Crown Sydney Hotel Resort Modification 3

Amalgamation of apartments
State Significant Development Modification Assessment
(SSD 6957 MOD 3)

July 2020

Figure 6 | Proposed 6 bedroom + study duplex apartment layout on Level 48 (Source: MOD 3)

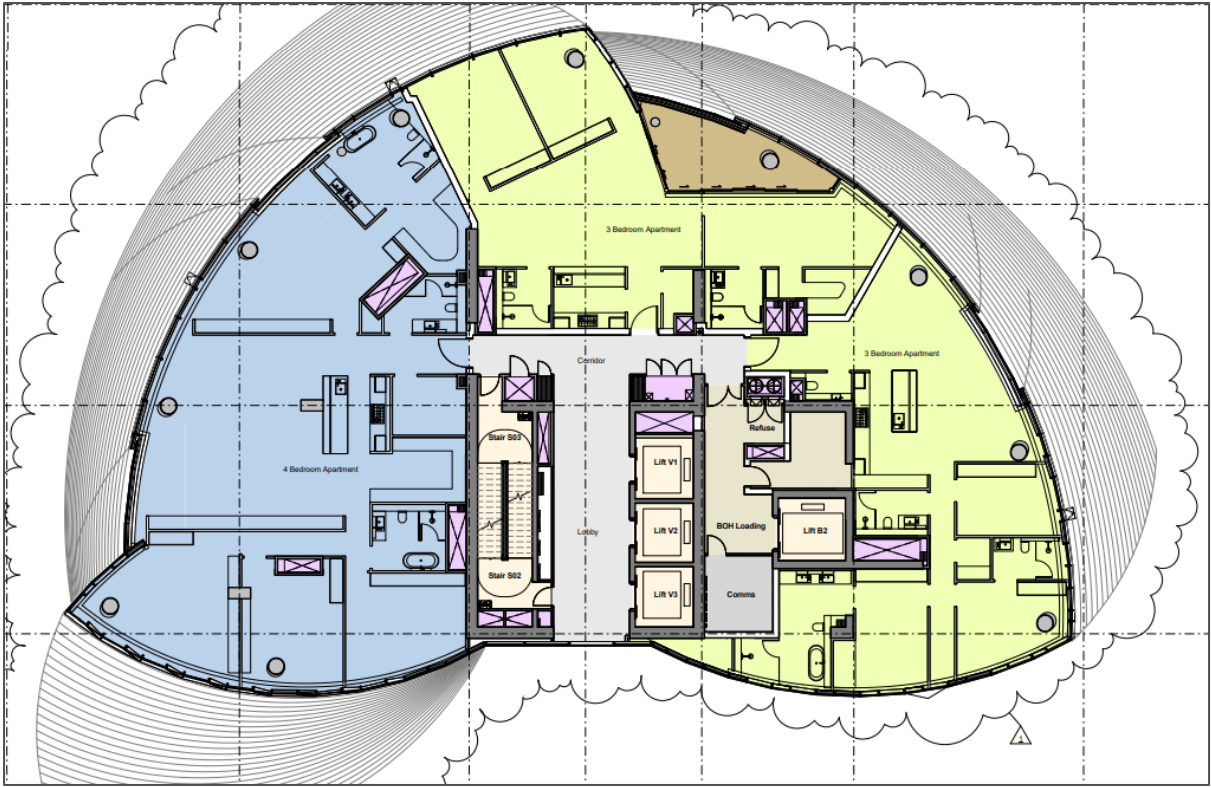
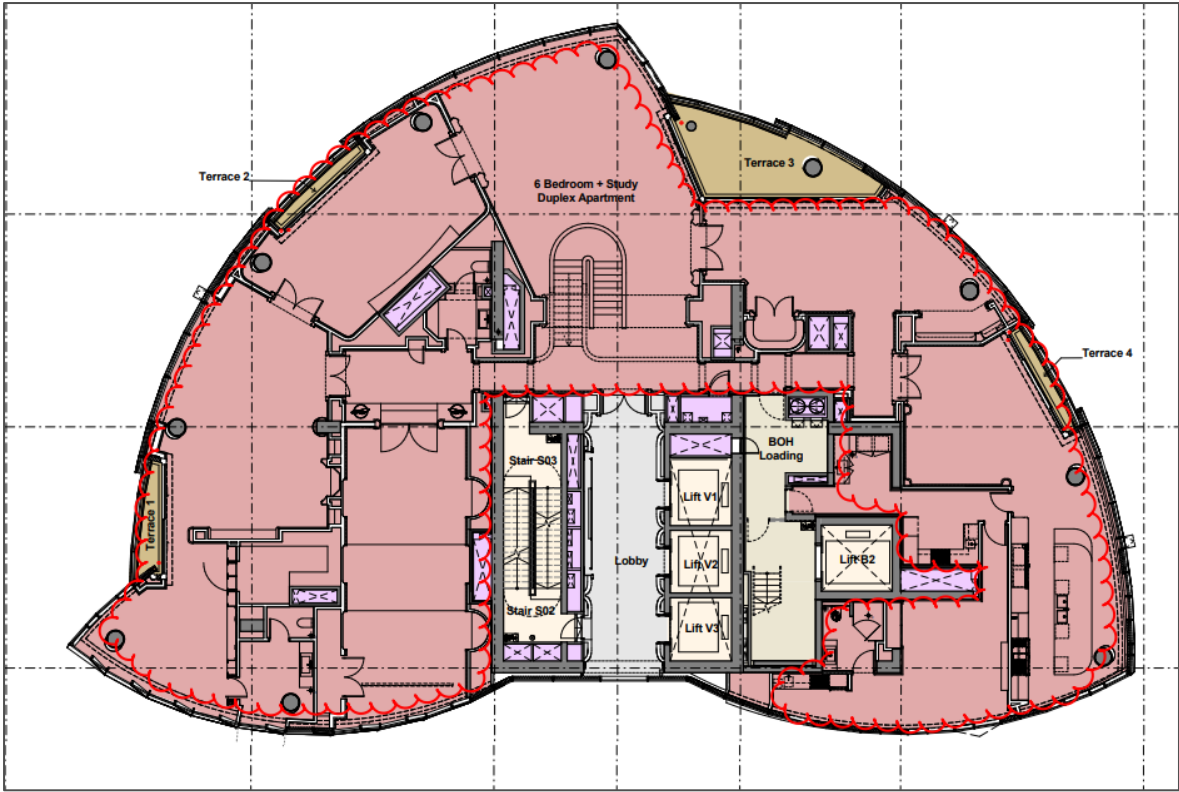
The proposed apartment amalgamation is described in **Table 2** below and shown in **Figures 4 to 7**.

Level	Approved	Proposed
Level 48	<ul style="list-style-type: none">• 2 x 3 bedroom apartment• 1 x 4 bedroom apartment	<ul style="list-style-type: none">• 1 x 6 bedroom + study duplex apartment
Level 49	<ul style="list-style-type: none">• 1 x 2 bedroom apartment• 1 x 3 bedroom apartment• 1 x 4 bedroom apartment

The proposal seeks to reduce the total number of approved apartments by five from 81 to 76 by amalgamating six apartments across two levels of the building (levels 48 and 49). The Applicant has advised the amalgamation of apartments into a single duplex apartment is necessary due to a specific buyer request.

The proposal would decrease the number of two-bedroom apartments from 25 to 24, decrease the number of three-bedroom apartments from 36 to 33 and decrease the number of four-bedroom apartments from 19 to 17. The proposal would create a new six bedroom plus study duplex apartment with a floor area of approximately 1,340 m².

The Department considers the revised unit mix is acceptable as the proposed changes are minor and the proposal retains an appropriate range of different unit types and sizes. The new apartment would still provide a high level of amenity for its future residents (considered further in **Section 5.3** and
